**Agenda Title:** DISCUSSION REGARDING WASTEWATER TREATMENT PLANT INFLUENT METERING SYSTEM EVALUATION

**Subject: Parshall Flume Design Memorandum**

SUBJECT: Review of City of Willits Wastewater Treatment Plant Influent Flow Meter  
B&R File No. 3478.00

5 MGD As Designed Condition

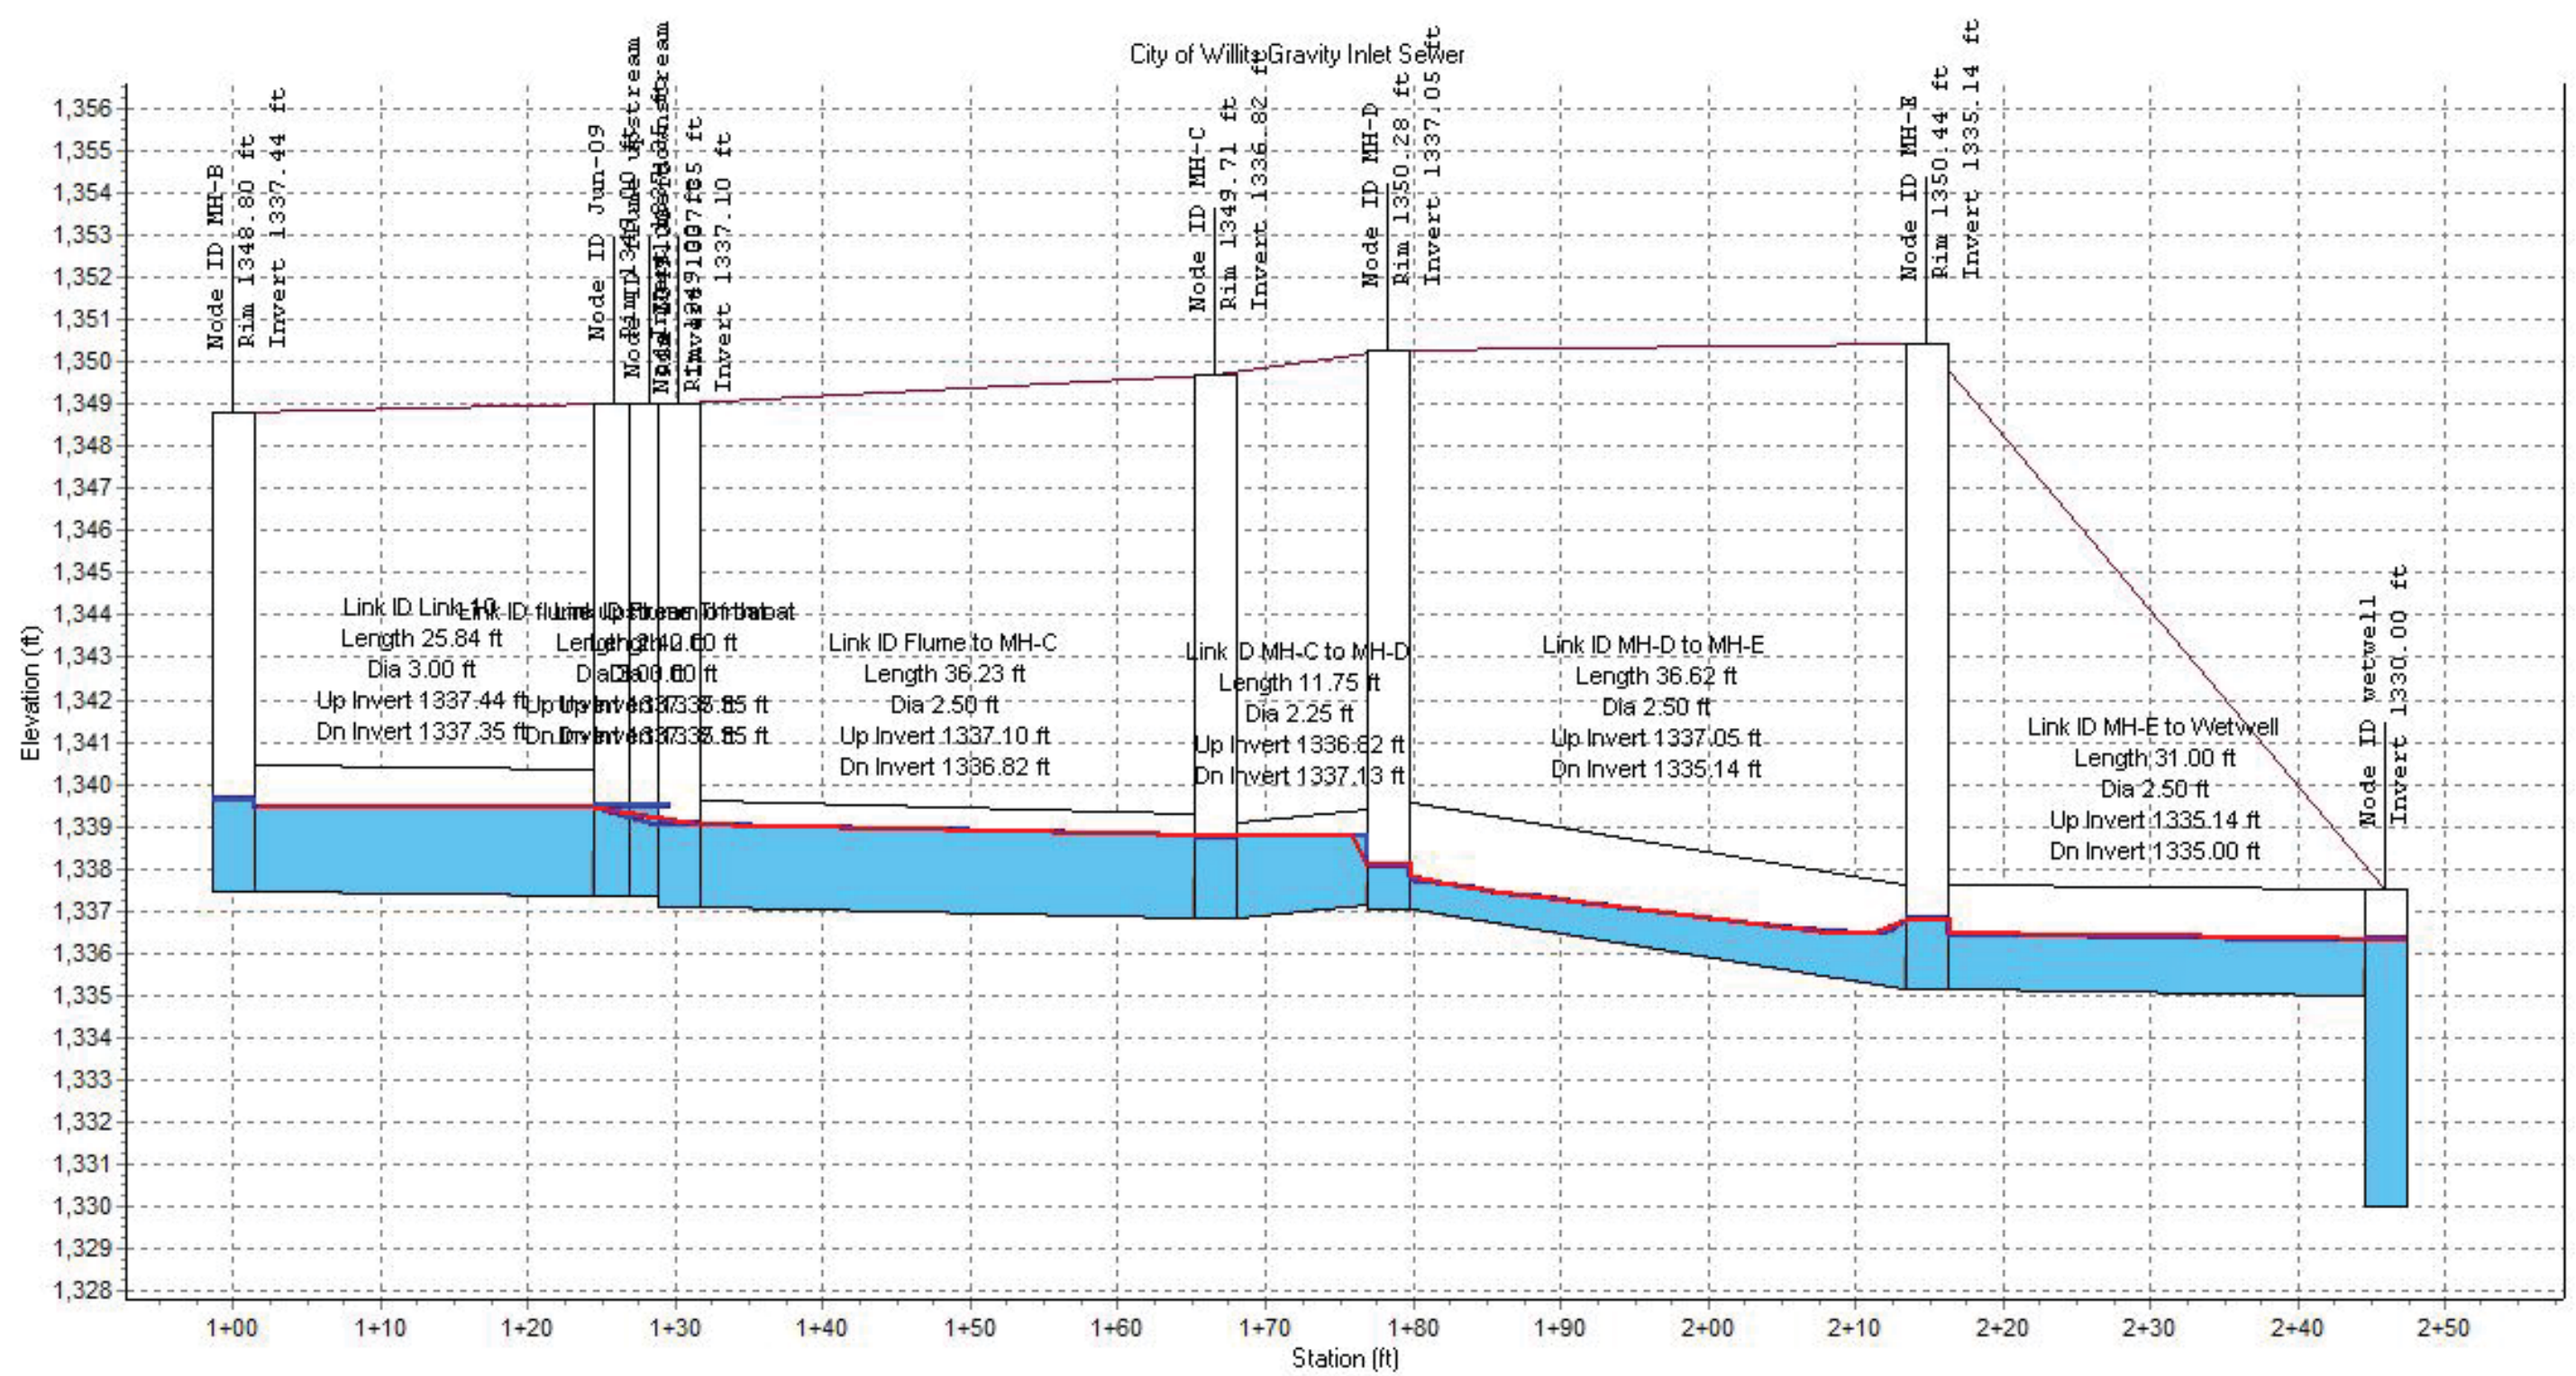
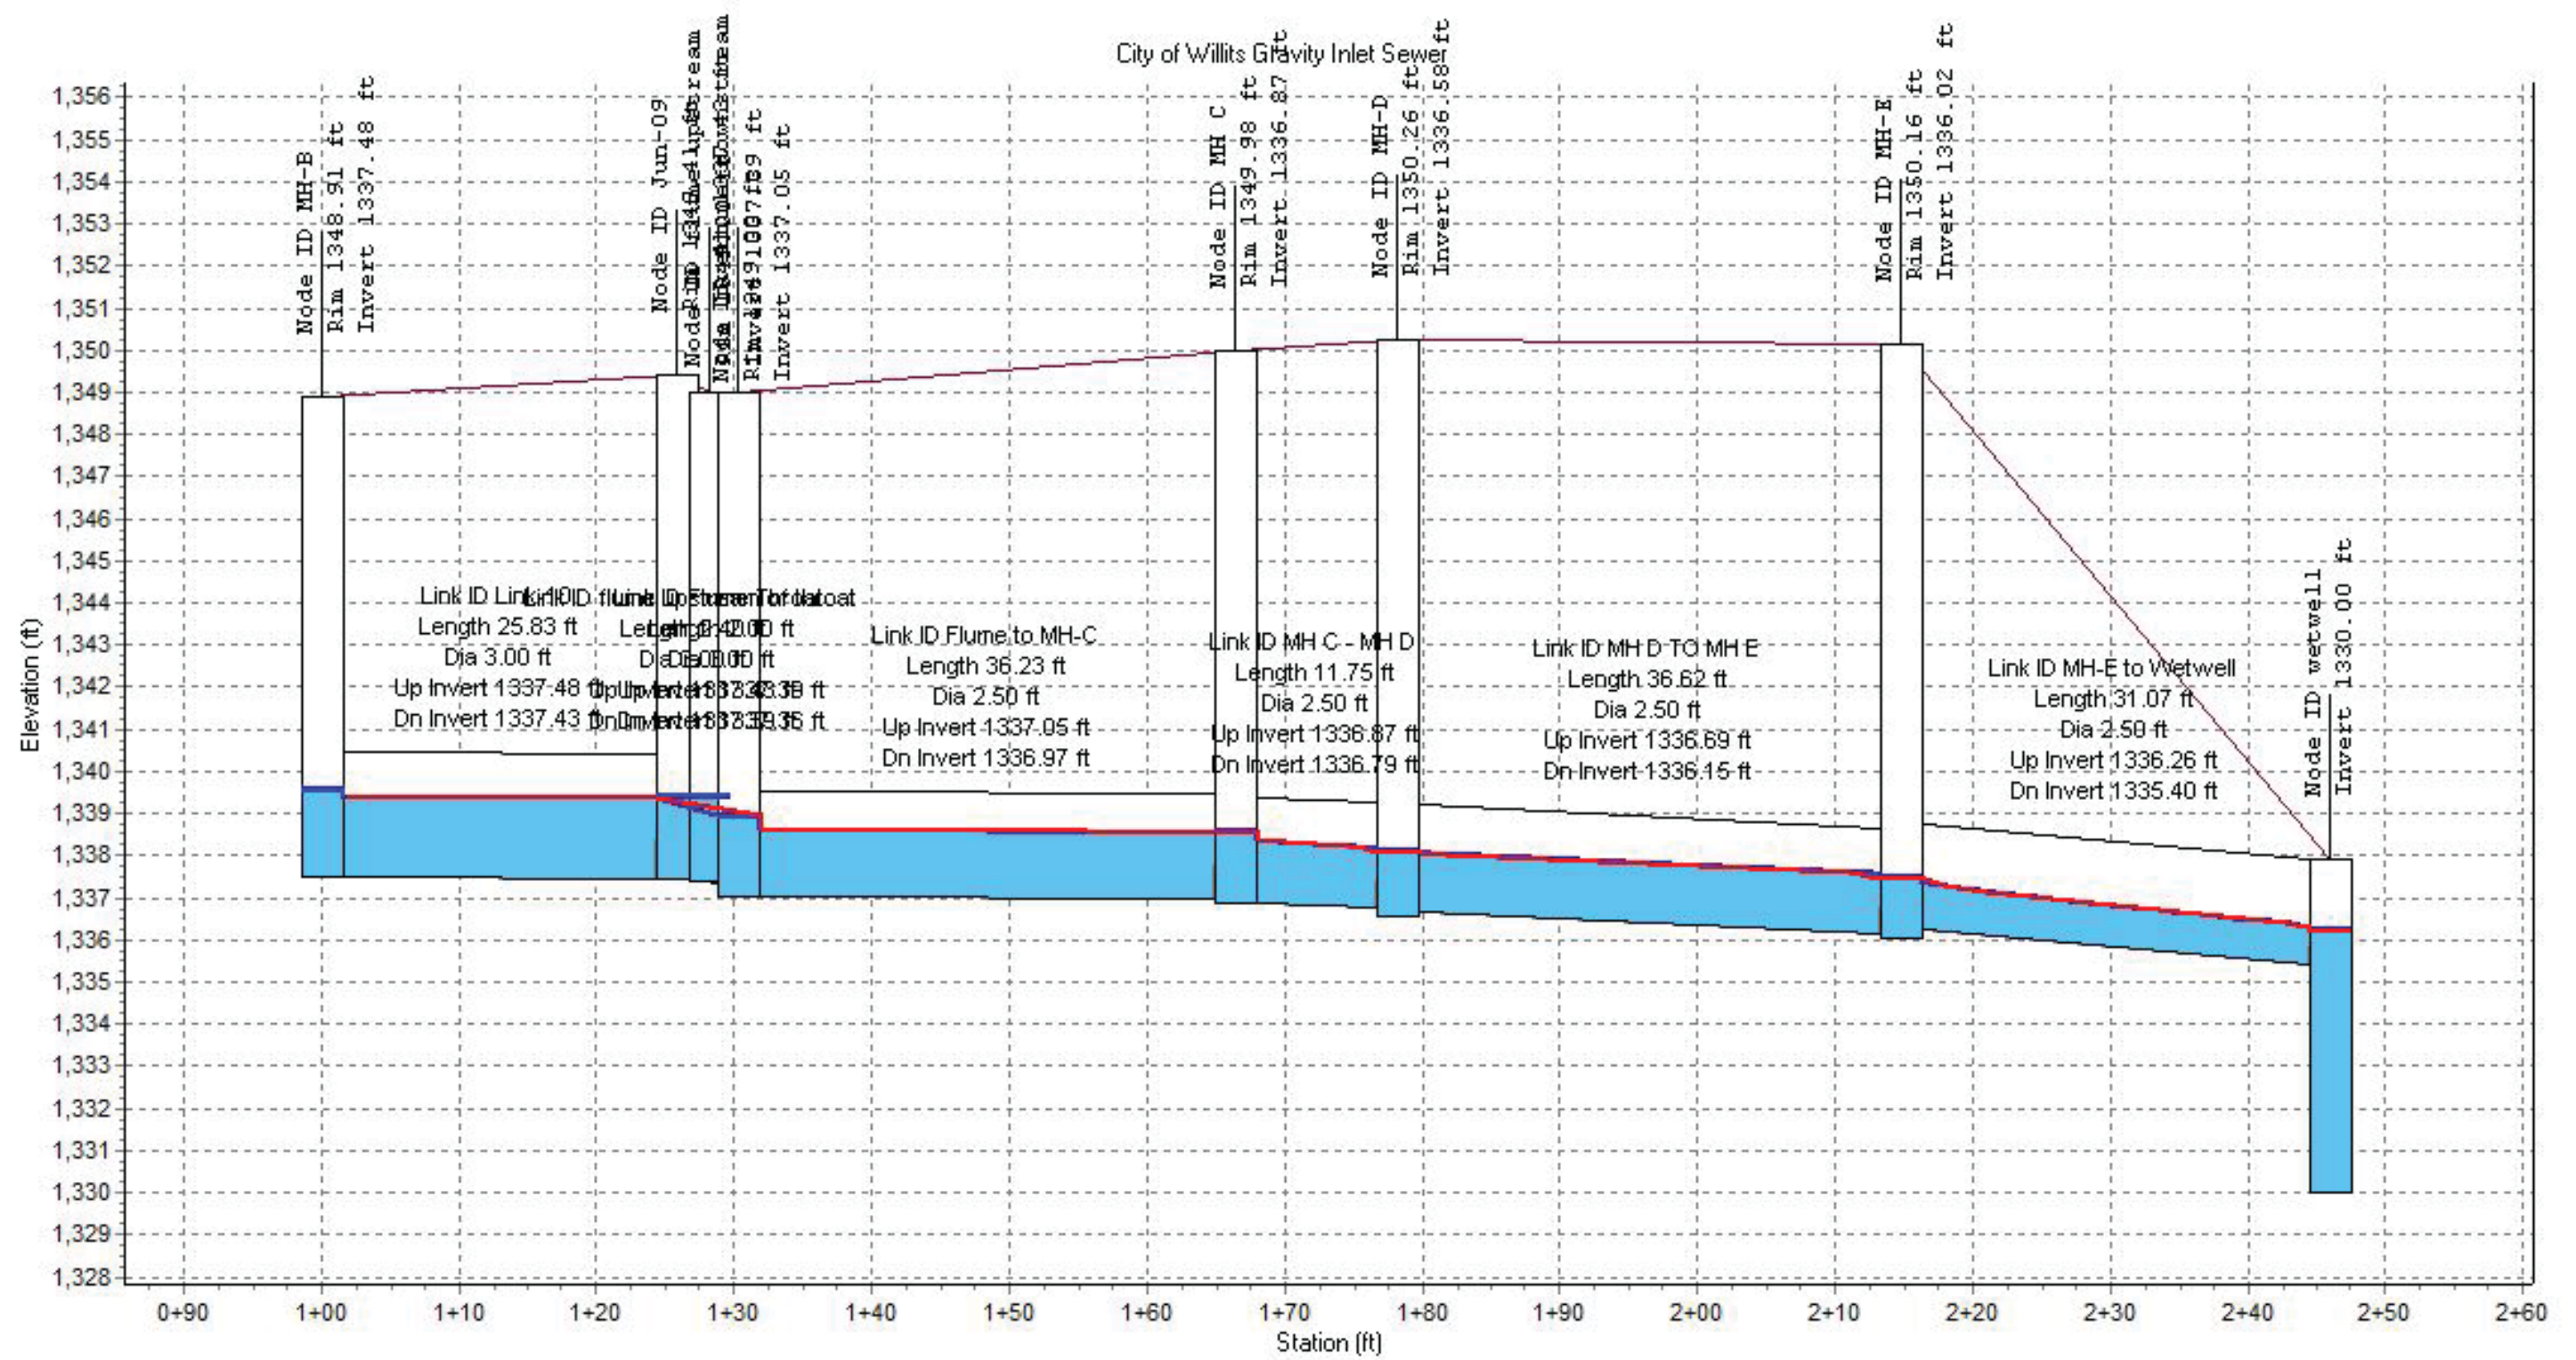
The overall model results (see attached hydraulic profiles) show that there are effects at the flume due to backwater under all three flow conditions for the as-built condition. Based on the published data, the backwater effect would result in a reading of 1.21 MGD vs. 1.18 MGD (2.5% increase), then 6.15 MGD vs. 5 MGD (23% increase), and finally 12.23 MGD vs. 10 MGD (22% increase). The model also indicates that at the as-designed condition, there would be some backwater effect at the 5-MGD and 10-MGD flow depths.

Based on discussions with a flume manufacturer, there are two ways to mitigate for the backwater effects on the flow measurement. The first is to raise the floor of the flume so that the bottom of the flume is above any backwater effects from downstream. The second is to install ultrasonic level readers at two locations along the flume. The level readings would then be fed to a programmable logic controller (PLC), which would use the correct theoretical equation, based on the presence or absence of backwater conditions, to calculate the correct flows to within the normal tolerance of a

TITLE 18" FLUME

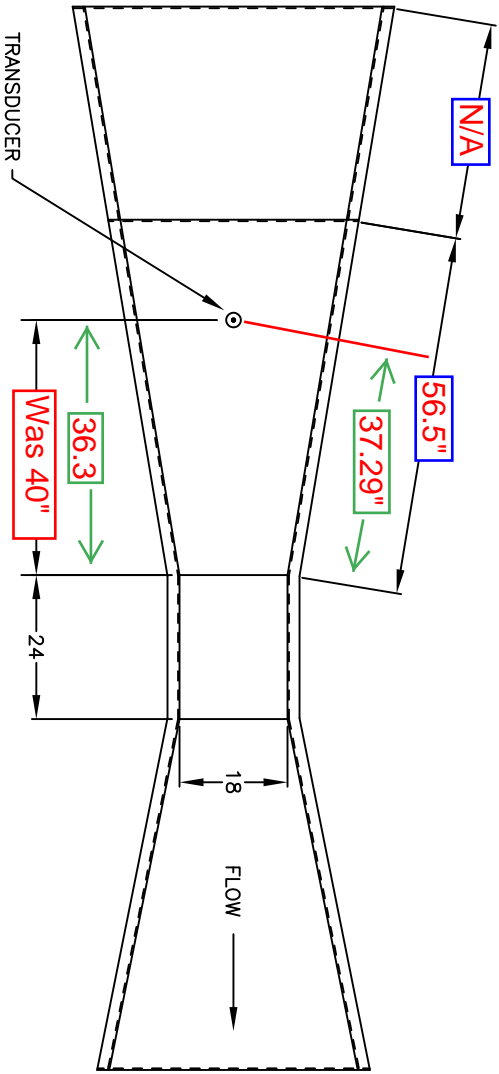
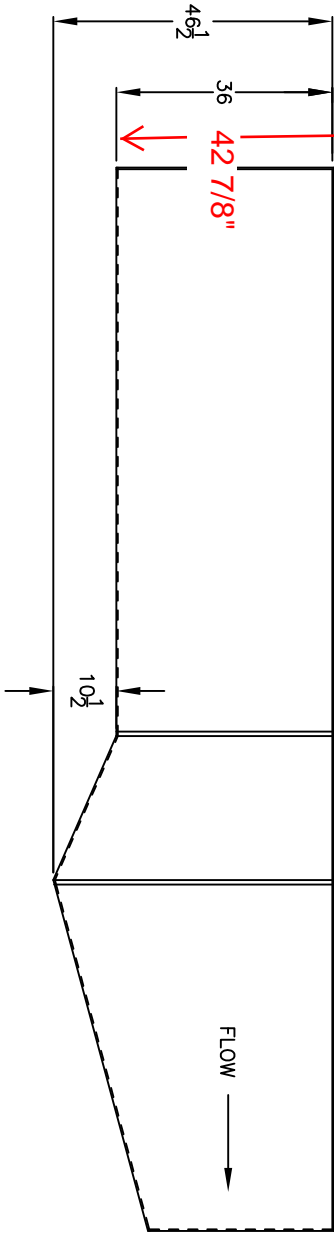
- The ultra-sonic transducer appears to be mounted too low. The manufacturer's manual specifies the face be greater than the "blanking distance" from the top of the flume (max head height). This is not the case as our drawing of measured dimensions shows. Blanking distance is set at 12 inches, which is likely near the minimum blanking distance for such a transducer and cannot be reduced. And while maximum head is set in the parameters at 30 inches, the top of the flume is 36 inches. Under normal conditions, this allows a margin of .5 inches. As the influent could get to 36 inches, the current installation is possibly inadequate under some conditions of high flow. It would be advisable to raise the transducer six inches or so if possible. (Blanking distance is the area close to the transducer in which it cannot accurately measure distances and the flowmeter is thus configured to ignore such false readings in that area.)

While we had come equipped to remove and replace the existing conduit and transducer mounting, it was found that the transducer mount was loose enough to allow it to be moved. So the transducer was simply relocated to the proper location and the existing hardware was retained. It should be made clear that "loose" meant the assembly could be moved with an 18" Rigid pipe wrench. It was by no means loose enough to move by hand. The end result was that the transducer location was satisfactorily corrected.

**Record Drawing, City of Willits Influent Metering Vault**

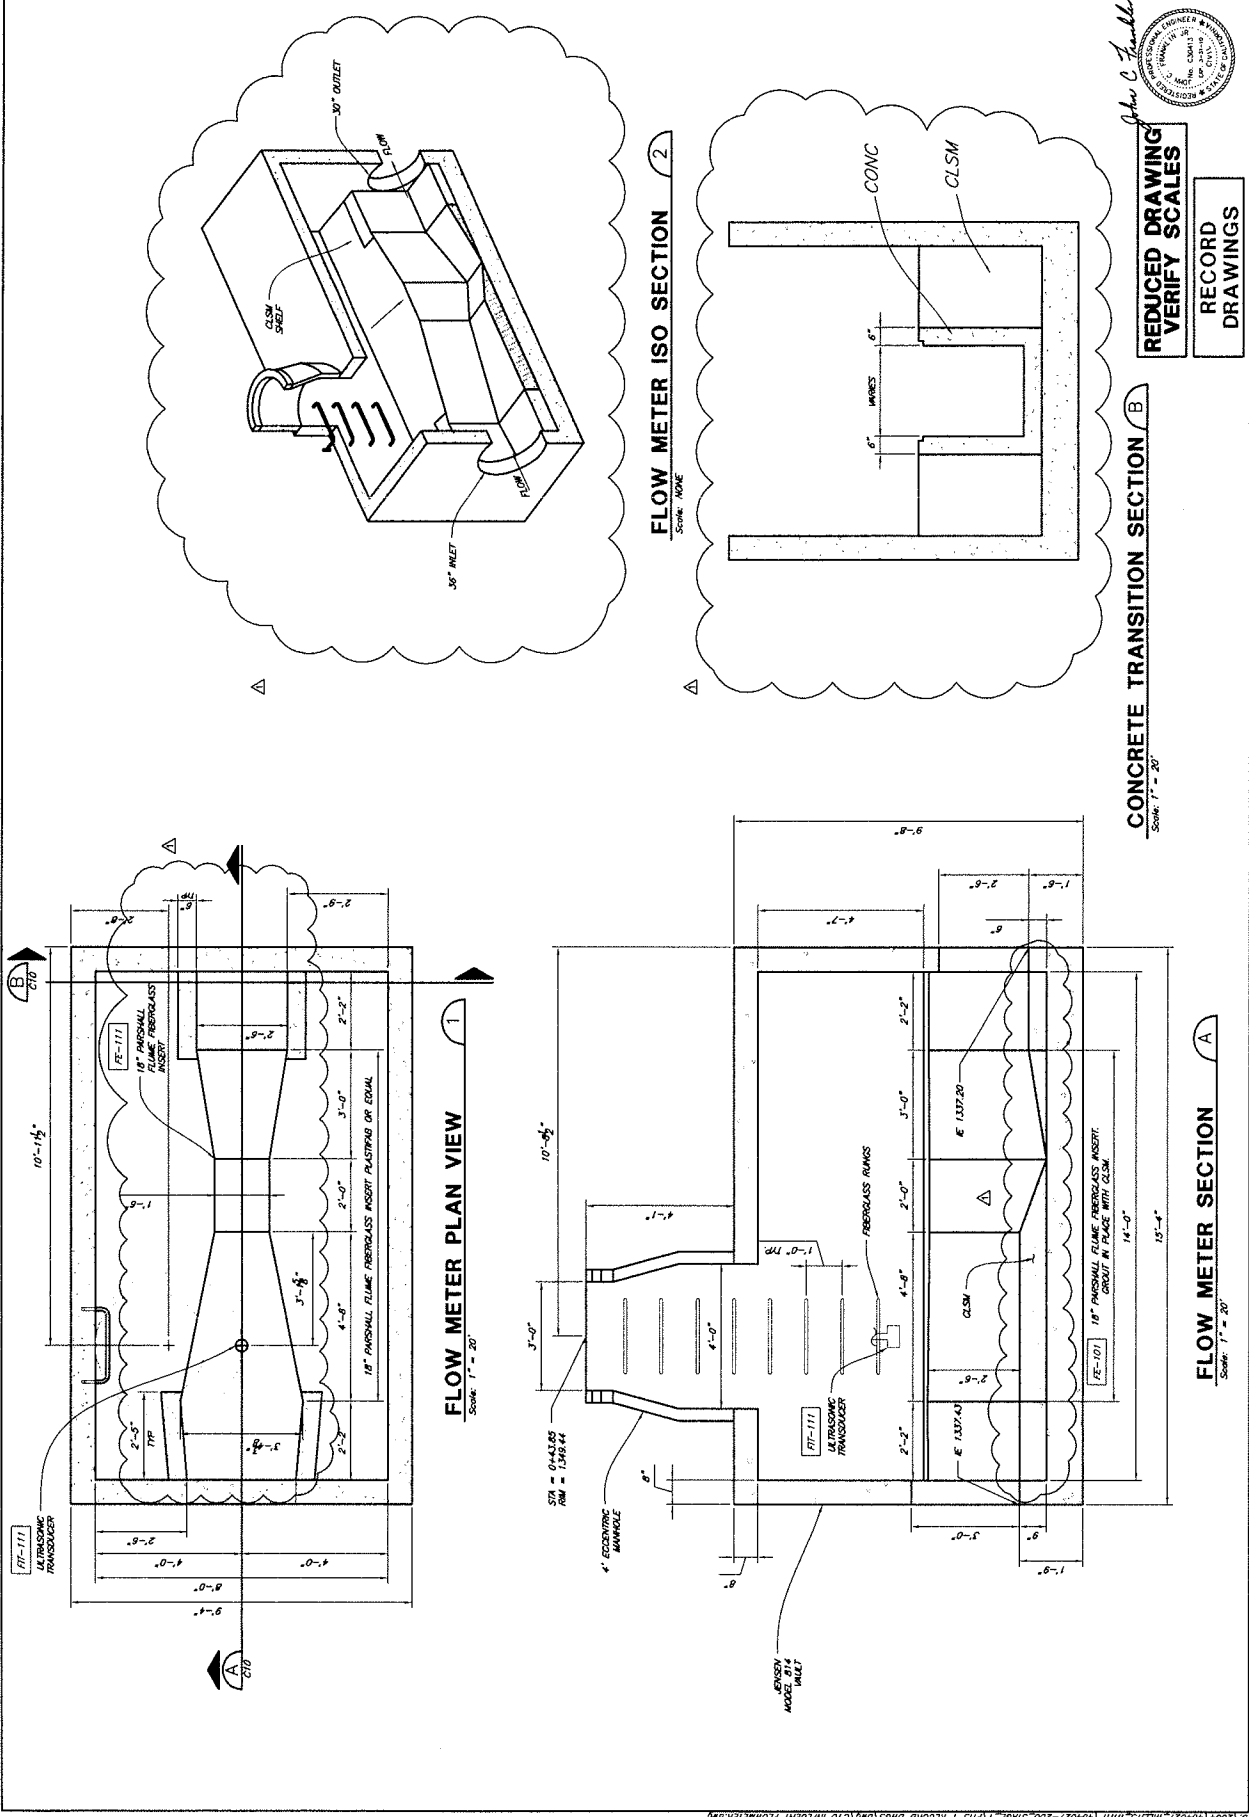
2. It was, however, observed that the walls of the influent channel from the sewer pipe outlet to the molded flume are not as shown in the as-built record drawing (Exhibit A). The drawing shows the walls going directly from the sides of the sewer pipe to the opening of the flume structure. In fact, the walls go from the corners of the vault to the flume opening, as can be seen in the attached Exhibit D, Photograph 1. This configuration creates triangular "coves" on each side of the channel. The coves may cause flow irregularities such as stagnant zones or eddies.
